UNITED STATES PATENT AND TRADEMARK OFFICE

APPLICATION NO.	FILING DATE	FIRST NAMED INVENTOR	ATTORNEY DOCKET NO.	CONFIRMATION NO.
09/989,845	11/21/2001	James E. Lerch JR.	011215	1251

Office Action Summary

DETAILED ACTION

3,258,250 (McMullin)

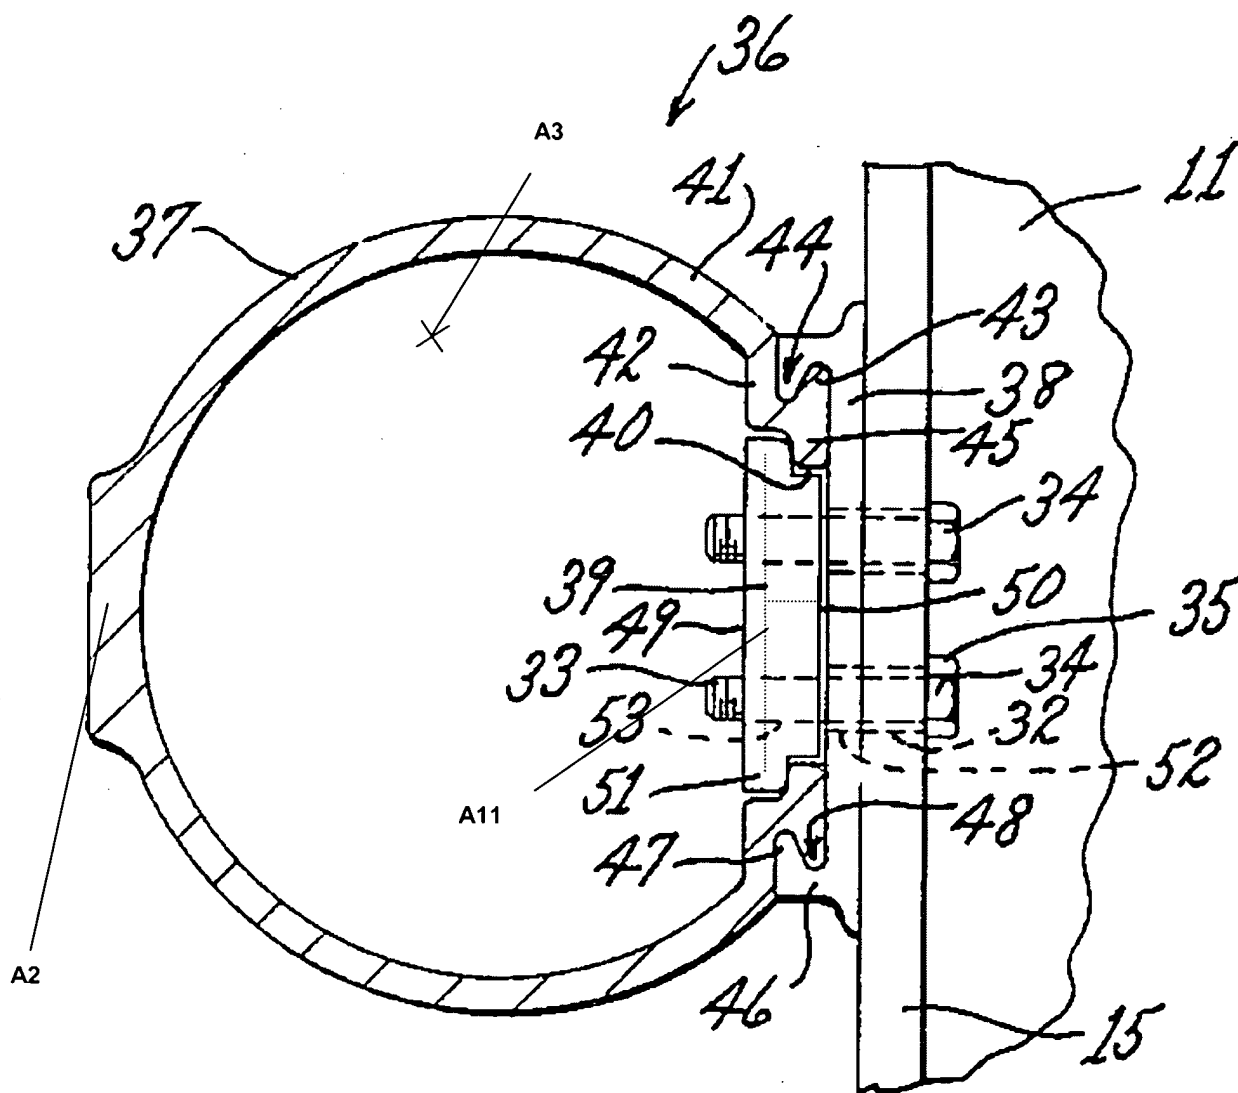
Regarding claim 1, McMullin discloses an improvement comprising at least one longitudinally extending railing 37, vertically extending posts 11, and fastening means 34. The railing 37 has at least one generally T-shaped channel A2. The channel A2

extends in a longitudinal direction **A3** of the railing **37** and at least one leg **45** of the channel **A2** extends inwardly within the channel **A2**. The posts **11** each have an elongated body **14** and at least two flange segments **A6**. The flange segments **A6** extend outwardly in opposite directions **A7** and have at least one perforation **32** in at least one of the flange segments **A6** (Fig. 1; attachment). The fastening means **34** are slidably embraced within the channel **A2** and the fastening means **34** extend through the perforation **32** in the flange segments **A6** and fastened to the posts **11**.

However, McMullin does not show another perforation in the other one of the flange segments **A6** thereby making each of the flange segments **A6** having at least one perforation to connect the rail. Case teaches in Figure 7 at least one perforation **71** in each flange segment **58** to connect a rail to a post. Therefore, as taught by Case, it would have been obvious to one of ordinary skill in the art at the time the invention was made to include at least one perforation **32** in each of the flange segments **A6** to connect the rail to the posts.

Regarding claim 18, McMullin discloses in Figures 1 and 3 an apparatus comprising a barrier **36**. The barrier **36** has at least one longitudinally extending railing **37**, vertically extending posts **11**, and fastening means **34**.

The railing **37** has at least one generally T-shaped channel **A2**. The channel **A2** extends in a longitudinal direction **A3** of the railing **37** and at least one leg **45** of the channel **A2** extends inwardly within the channel **A2**.

The posts **11** each have an elongated body **14** and at least two flange segments **A6**. The flange segments **A6** extend outwardly in opposite directions **A7** and have at least one perforation **32** in each of the flange segments **A6**.

The fastening means **34** are slidably embraced within the channel **A2** and the fastening means **34** extend through the perforation **32** in the flange segments **A6** and fastened to the posts **11** to provide a variably select elevation of the longitudinally extending railing.
